Proposed Revisions to a Standard Plans Index

Index Number: 455-060

Index Title: 60" Prestressed Concrete Cylinder Pile

ELEVATION

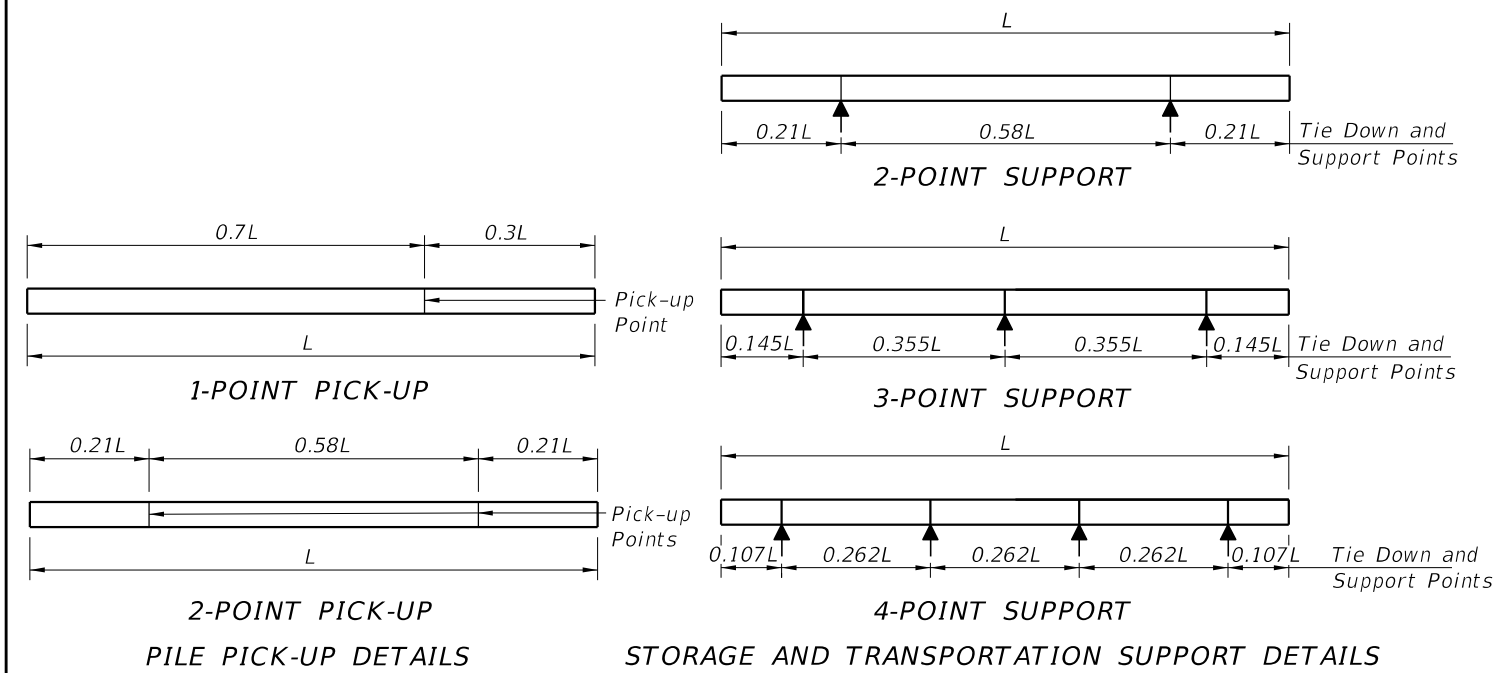
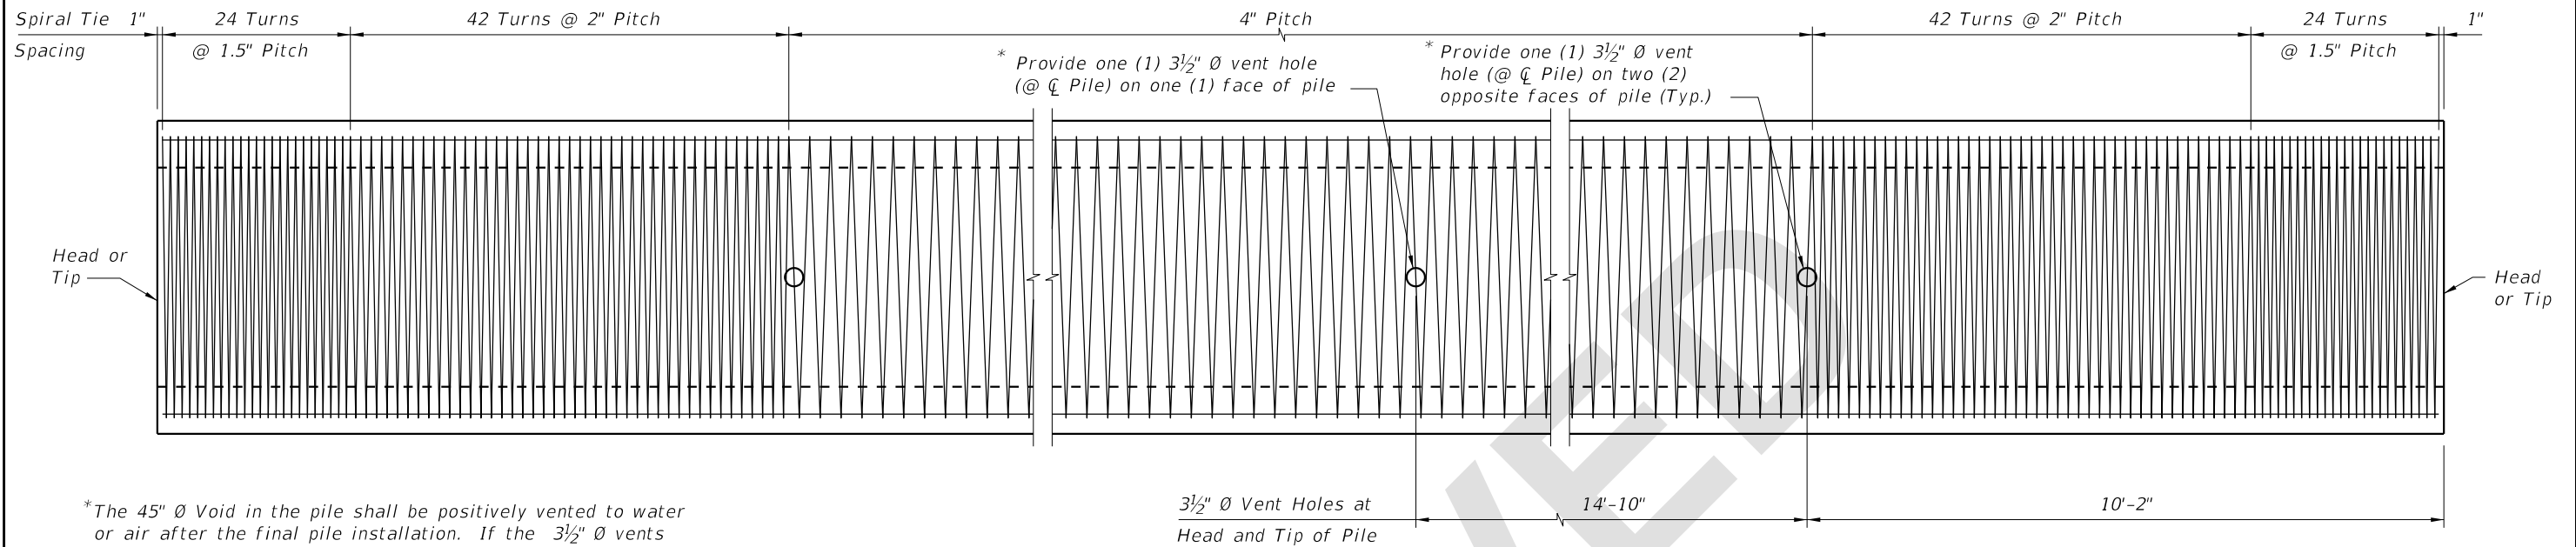
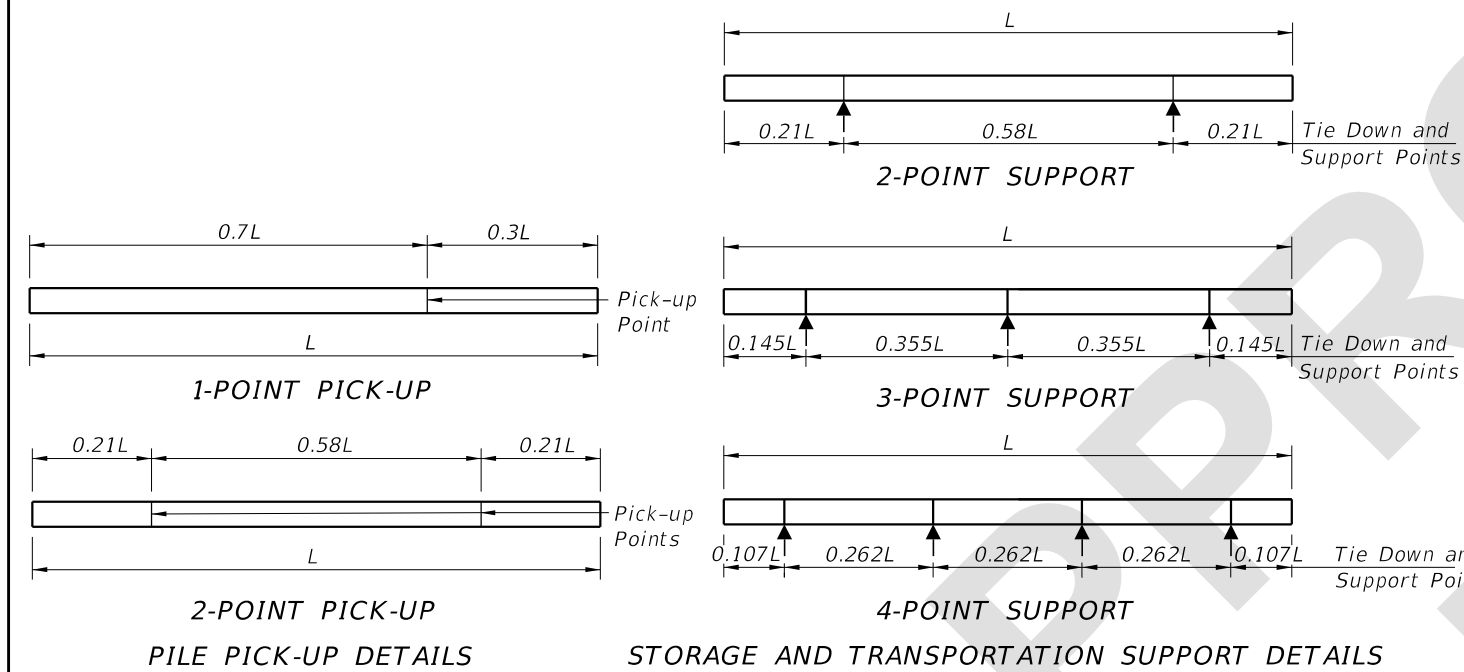
Changed Class V (Special) concrete to Class V.

- Work this Index with the Pile Data Table in the Structures Plans.
- Concrete:
 - Piles: Class V (~~Special~~)
 - Splice Collar: Class IV
 - See "GENERAL NOTES" in the Structures Plans for locations where the use of Highly Reactive Pozzolans is required.

1. Work this Index with the Pile Data Table in the Structures Plans.
2. Concrete:
 - A. Piles: Class V
 - B. Splice Collar: Class IV
 - C. See "GENERAL NOTES" in the Structures Plans for locations where the use of Highly Reactive Pozzolans is required.
